Document No.: RN-240708-01
Date: July 08, 2024
Classification: External
Priority Routine
Attn: All Customers
Related Products: C700
Subject: **C700 One Firmware Release Note – V2.0.0**

1. Improvements

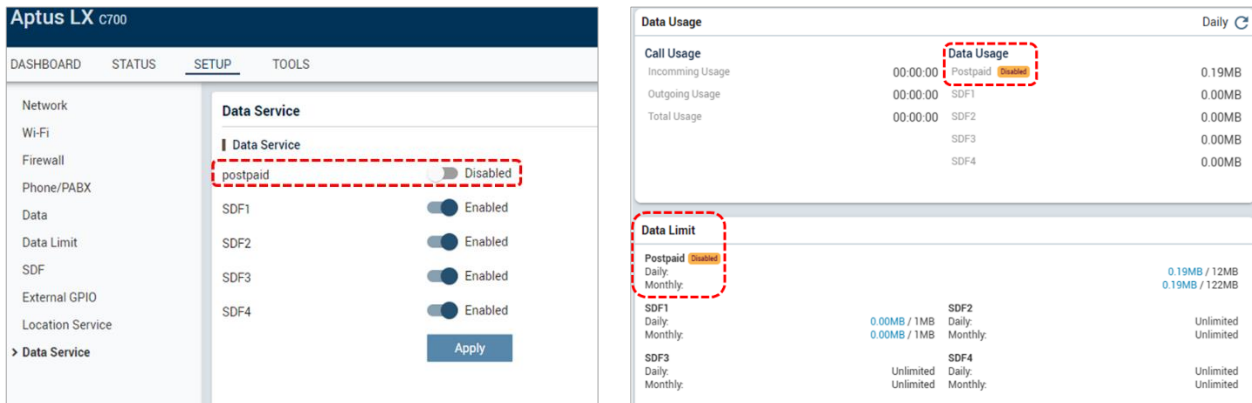
- 1.1. Implements framework that enables a reduction in the size of future FW updates (estimate reduction from 47.2MB → 16.1MB)
- Please refer to the Remarks section below for detailed information
- 1.2. When Data Service is disabled, the data will not be used.

- 1.3. BCX FW updated to 2.8.1-D337161E.
- 1.4. The four cyber security weaknesses identified by incibe (Iridium Customer - National Institute of Cybersecurity of Spain) have been fixed. 4 vulnerabilities in Intellian Certus 700 discovered was Cryptographic Issues, Improper Input Validation, Use of Hard-coded Credentials, Improper Check for Unusual or Exceptional Conditions.
